FROM: Peter Johansson  
TO: T10 SBP-3 working group  
DATE: February 19, 2001  
RE: Bridge-aware targets and node handles

The pages that follow contain proposed additions to the SBP-3 working draft that incorporate some, but not all, of the functionality required for "bridge-aware" targets. One clause is (informative) introductory material to be added to the model while the other is a new management ORB used to obtain a node handle from the target.

**Figure 28a – Get node handle ORB**

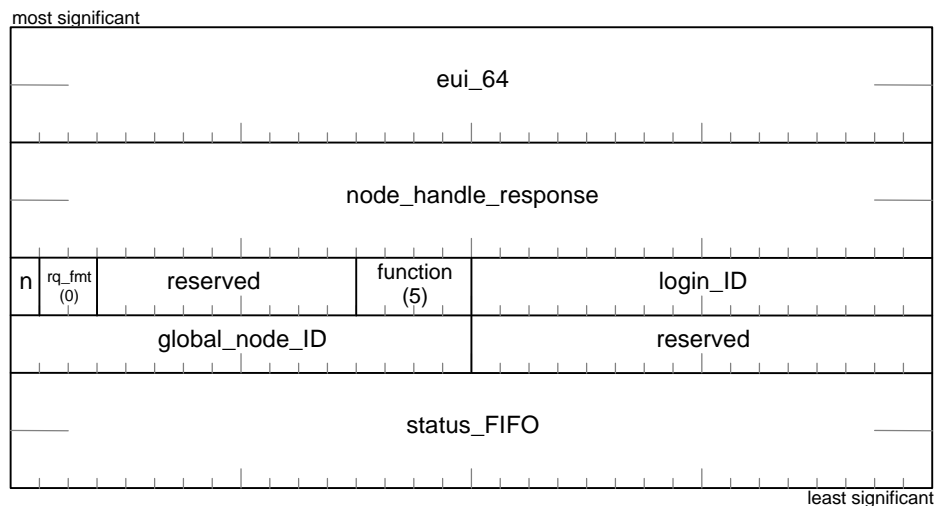
When an initiator establishes a login in bridge-aware mode, it shall obtain node handle(s) to use in all address pointers signaled to the target for the duration of the login. A node handle for a particular node, identified by its EUI-64, may be obtained by a get node handle request that uses the ORB format shown below.

The *eui\_64* field shall contain the unique identifier of the node for which the node handle is requested and shall not be equal to the initiator's EUI-64.

The *node\_handle\_response* field shall specify the address of a quadlet buffer allocated for the return of the node handle. The *node\_handle\_response* field shall conform to the format for address pointers specified by Figure 11. The buffer shall be accessible to a Serial Bus quadlet write request.

The *login\_ID* field shall contain a login ID value obtained as the result of a successful login.

The initiator may set the value of the *global\_node\_ID* field to provide a hint to the target. When the value is all ones, no hint is given. Otherwise, *global\_node\_ID* contains a global node ID that may identify a node whose EUI-64 matches that specified by the *eui\_64* field. In this case, the target, in place of an EUI-64 discovery search, may use a TIMEOUT message (as specified by draft standard IEEE P1394.1) to validate whether or not *global\_node\_ID* correlates with the specified EUI-64.

The *status\_FIFO* field is as previously defined for management ORB formats and shall contain an address allocated for the return of status for the GET NODE HANDLE request, only. The contents of this field shall not update the status FIFO address established by the successful login that returned *login\_ID*.
